**Final Determination on the
Appropriateness of the Model Year
2022-2025 Light-Duty Vehicle
Greenhouse Gas Emissions Standards
under the Midterm Evaluation**

Response to Comments

U.S. Environmental Protection Agency
Assessment and Standards Division

Figure 2-1 Most Cost-Effective Technology Packages Considered by EPA: Vehicle Type 1, Low Power-to-Weight, Low Road Load Vehicles (Small Car in Draft TAR) w/ I4 DOHC

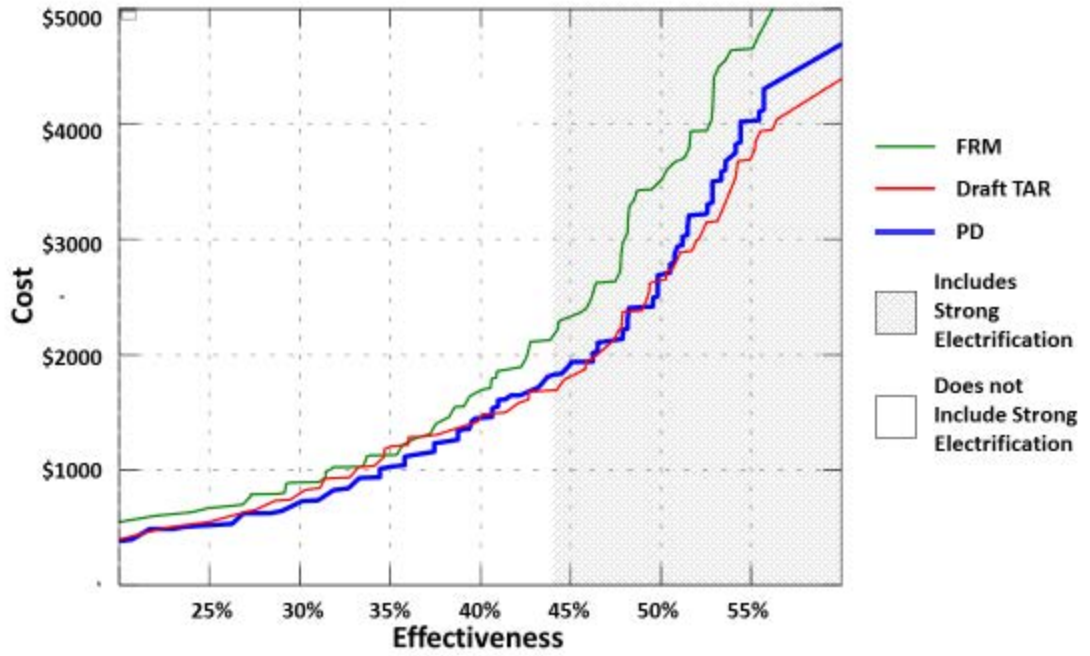
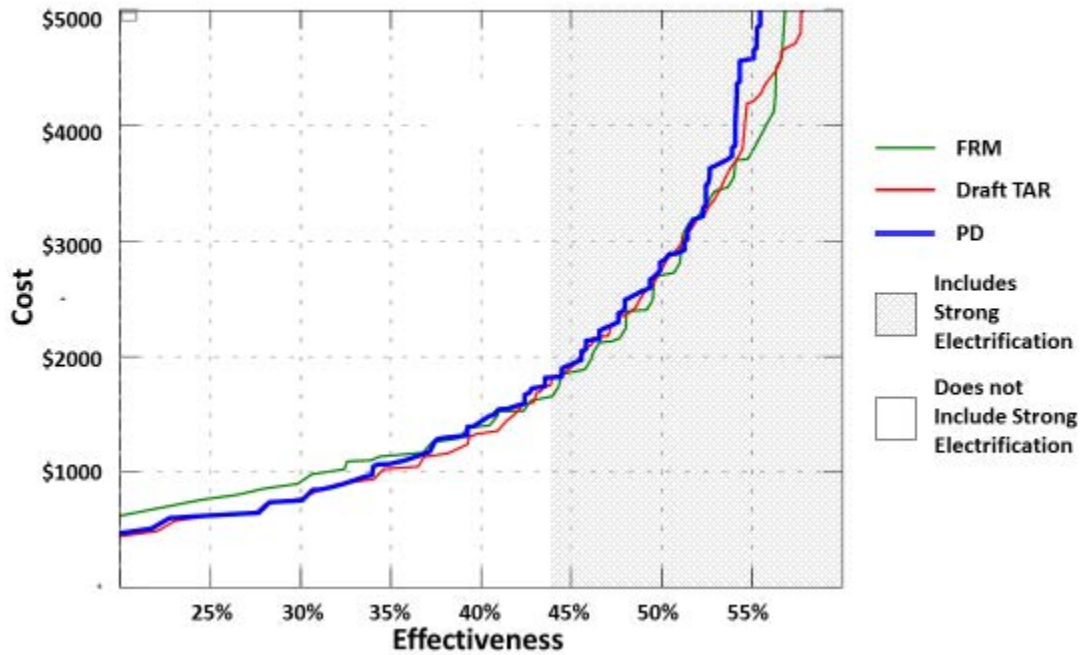
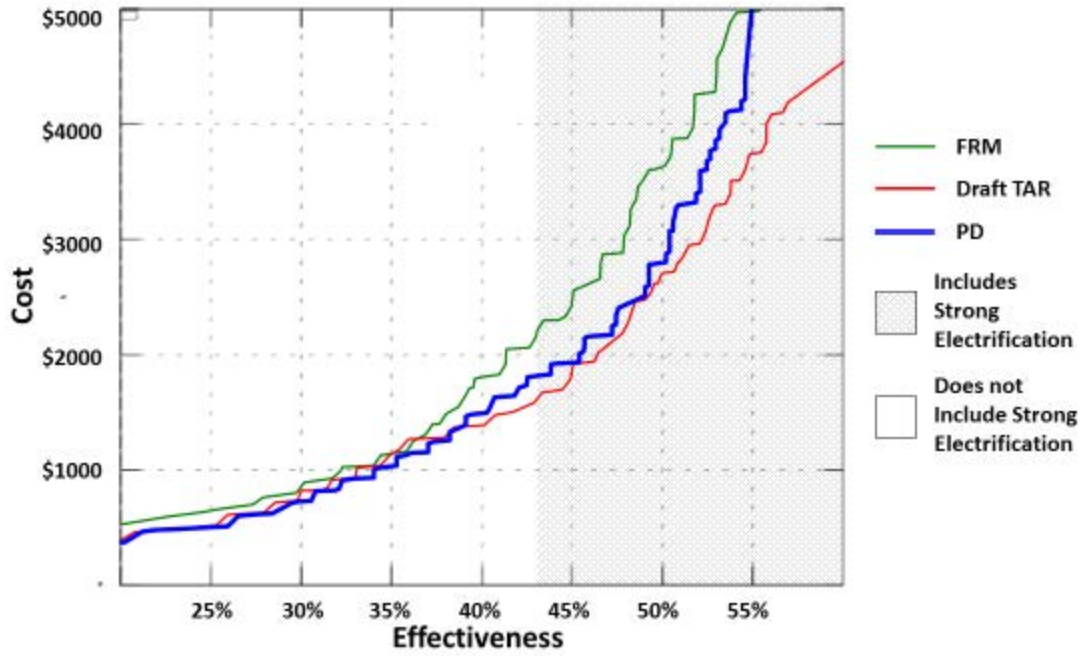
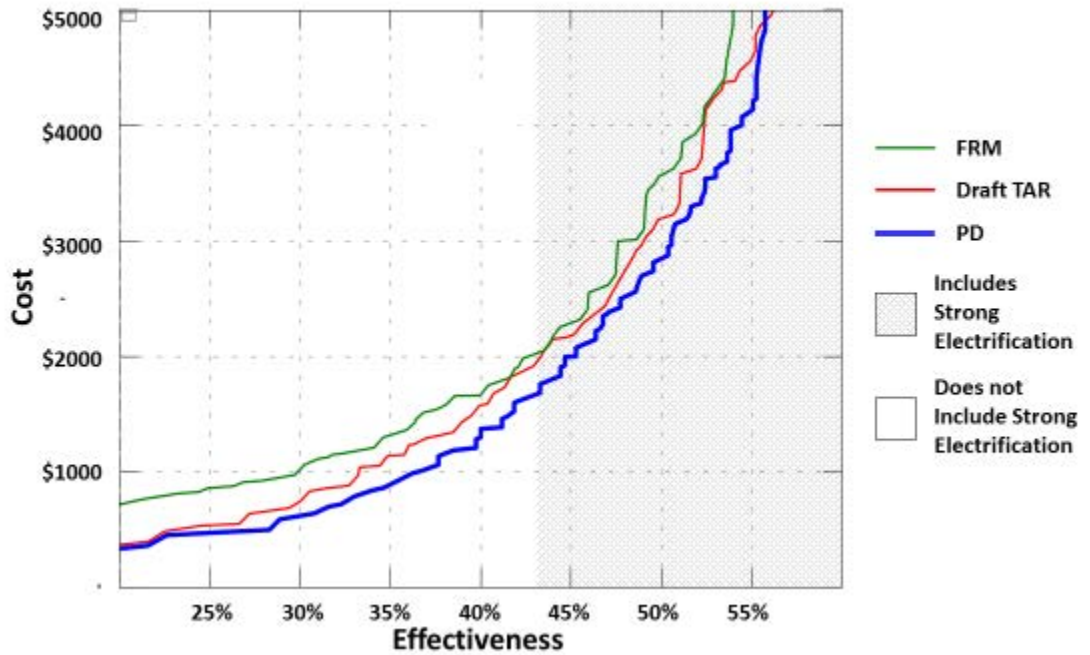
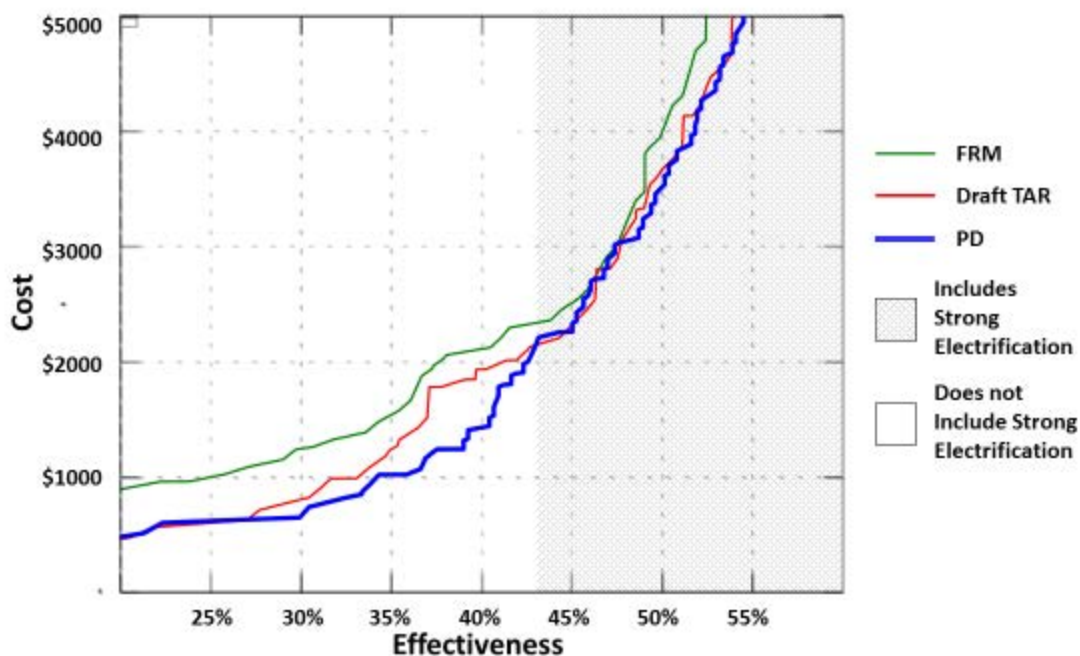
OEM commenters also aimed criticism at differences in projected penetrations of individual technologies between the Draft TAR and the 2012 FRM, characterizing these differences as evidence that the agencies' analysis approach was unsound. In response, EPA pointed out that these differences are not evidence of a flawed analysis but are a natural result of the Draft TAR having recognized and included innovations and improved efficiencies that occurred since the 2012 FRM, the very sorts of improvements that the Alliance contractor report assumed would not occur between now and 2025. See Proposed Determination at p. 24. In addition, the technologies reflected in the Draft TAR and Proposed Determination analyses reflect many of the technology changes that have been introduced in the fleet since the 2012 FRM. Thus, EPA would be remiss to not consider these technologies within the context of the MTE. The 2015 NAS report also recognized these important emerging and changing technologies, such as Atkinson cycle engines and CVTs, and recommended that the agencies consider these technologies in their future analyses. EPA thus disagreed that such differences in projected technology penetrations indicate in any way that the analysis and analytic approach were unsound. On the contrary, the incorporation of new technologies and unforeseen applications since the 2012 FRM would necessarily influence the cost-effective pathway modeled by EPA. *Id.* at p. 25. For example, the application of direct injection Atkinson cycle engines in non-hybrids, greater penetration of continuously variable transmissions (CVTs), and 48-volt mild hybridization have all influenced projected technology penetrations, as have developments in downsized turbo-charged engines, cylinder deactivation, and electrification. EPA also noted the consistently low level of strong electrification projected in the 2010 TAR, 2011 NPRM, 2012 FRM, and 2016 Draft TAR, as further corroborated by the 2015 National Academy of Sciences (NAS) study. This consistency has persisted even as EPA's technology assessment and compliance analysis has undergone many updates and improved in its precision over the past six years, further supporting EPA's determination that the MY2022-2025 standards remain appropriate. *Id.*

While the technology types considered and their projected penetrations have indeed changed over the time span between the 2012 FRM, Draft TAR, and Proposed Determination, these changes are largely due to the innovation of the automotive industry being reflected in our updated analyses. Furthermore, even as these technologies and penetrations have changed, the stability of EPA’s estimated costs for complying with the standards support the conclusion that there are several viable cost-effective alternative pathways to meeting the MY2025 standards and that substantial levels of electrification will not be required. For example, transmission technology is one example of how competing technologies may evolve due to innovation to produce parallel options with little difference in cost or effectiveness. While the compliance costs will tend to be stable due to competition between multiple similarly cost-effective technologies, when a minor change in cost-effectiveness for one technology does occur (e.g., due to innovation), the projected penetration of the various competing technologies can change, in some case significantly. In the 2012 FRM, based in part on input from the auto industry and other stakeholders, EPA’s assessment was that dual clutch transmissions (DCTs) would provide a better opportunity for significant improvements in vehicle efficiency than continuously variable transmissions (CVTs), due to indications that CVTs demonstrated characteristics that were unacceptable to U.S. consumers. However, since the 2012 FRM, it became clear that early implementations of DCTs were experiencing some consumer resistance, while CVTs were becoming well accepted in the market due to ongoing improvements (for example, improvements to control strategies, such as the implementation of indexed shifting to simulate the feel of a conventional automatic transmission). As a result, penetration of CVTs had become much greater than originally expected. In addition, improvements have been made in each type of automatic transmission such that the relative difference in efficiency between transmission architectures is rapidly diminishing. EPA believes that the changes reflected in each of EPA’s analyses are the natural result of our representing in these analyses the continuing innovation in the light-duty market, and are not indicative of volatility, instability, or unsoundness as some commenters suggest.

Further, an examination of the cost-minimizing technology pathways also supports the stability of the assessments. Figure 2-1 through Figure 2-5 below show the curves that define the cost-minimizing technology package at each level of effectiveness (‘frontier curves’) for small car, standard car, cross-over utility, sport utility, and pickup truck vehicle classes. In these Figures, the technology cost-effectiveness estimated by EPA is shown to have generally improved in the Draft TAR and Proposed Determination (lowered frontier curves) relative to the FRM assessment, consistent with lower cost and/or higher effectiveness values that were identified in some cases by EPA when considering additional technologies and updated information in these most recent assessments. We note in these figures that conventional, non-electrified gasoline technology packages reside primarily in the region below 45 percent effectiveness, which is also the range of effectiveness values that will generally enable manufacturers to achieve the 2022-2025 standards. Within this critical range of effectiveness values, it can be seen that technology cost-effectiveness has remained within a narrow band between the Draft TAR and Proposed Determination – a finding that directly contradicts the commenter’s assertion of “radical changes” that would call into question EPA’s conclusions regarding the sufficiency of conventional non-electrified technologies. On the contrary, the consistency between the Draft TAR and Proposed Determination frontier curves shown in Figure 2-1 through Figure 2-5 is a direct indication of the general stability in EPA’s modeling.

Figure 2-6 Two Engine BSFC Maps, Reproduced in Technology Effectiveness – Phase II: Vehicle-Level Assessment

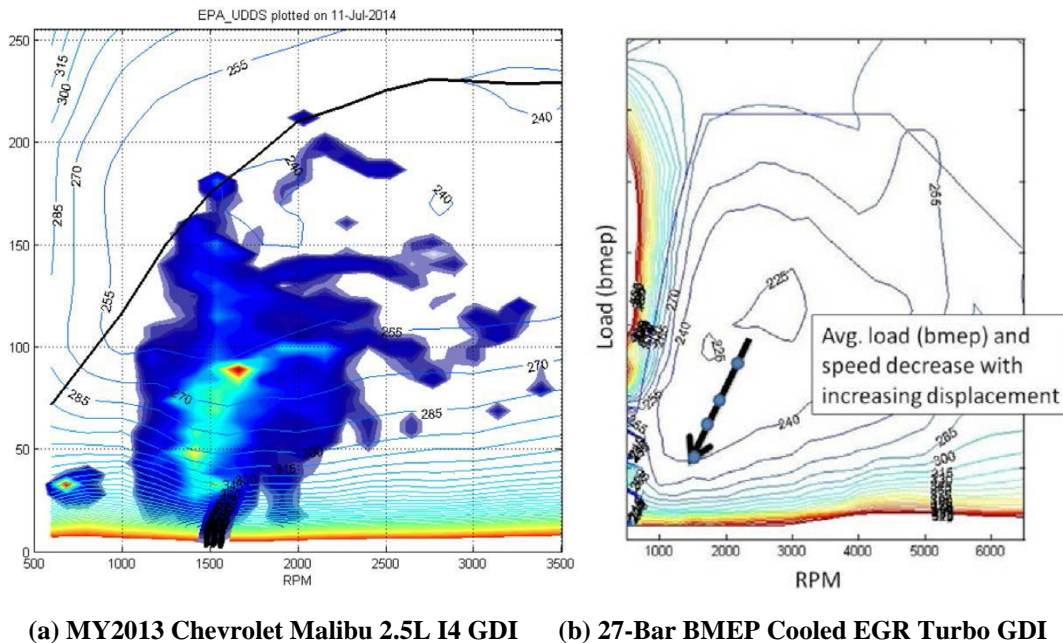
In the TSD Appendix A, EPA gave an example of the overly restrictive assumptions Novation uses, specifically using current engine technology to determine the limit of on-cycle-to-peak engine efficiency ratio (“Plausibility Test 2”). The example refers to two engine maps, a MY2013 Chevrolet Malibu 2.5L I4 GDI map and a 27-bar BMEP cooled EGR turbo GDI map (Figure 1.1 in the TSD Appendix A, and reproduced as Figure 2-6 in this RTC document). The 27-bar BMEP cooled EGR turbo GDI map has an enlarged area of high efficiency in the lower left (indicated by the arrow in Figure 2-6b). Since this is the area where engines tend to run over the cycle, the figure shows an example of how the application of engine technology can result in a better match between engine operation and peak efficiency. This reduces CO₂ emissions, precisely by increasing the on-cycle-to-peak engine efficiency ratio. A comment received from UCS agrees, stating in addition that “[l]owering this ratio is precisely the objective of much of the research on conventional spark-ignition engines.”

Novation in their comments further disagrees with EPA’s example of the overly restrictive nature of their plausibility checks by stating that EPA “relies on an illustrative example of an engine map that is not from an actual, tested engine.” In response, EPA agrees that this is an illustrative example, all the more so since the 27 bar map shown, and included in Novation’s original report, contains the overlaid arrow indicating how the area of greater efficiency is expended to the lower left, to better match the operating range of the engine during vehicle cycle operation. This is specifically illustrative of potential improvement in efficiency matching, and also illustrates UCS’ comment that lowering the on-cycle-to-peak engine efficiency ratio is precisely the objective of much of the research on conventional spark-ignition engines.

Novation continues in their comments, “[f]urthermore, the technology assumed from this map was not included in the TAR or the Proposed Determination.” Although this statement is something of a non sequitur, the 27 bar Ricardo map shown in Figure 2-6, and the underlying technology package, was indeed used to create 24 bar turbo downsized maps for the Draft TAR and the PD.

However, because the Novation report develops their plausibility limit for on-cycle-to-peak engine efficiency ratio based on a few MY2013-2014 vehicles, there is no room left below their arbitrary limit for the potential improvement in the efficiency matching shown in Figure 2-6. Put another way, the plausibility limit developed by Novation implicitly assumes that any potential improvements in engine technology which increase the efficiency of the engine while operating, relative to peak engine efficiency, are implausible.
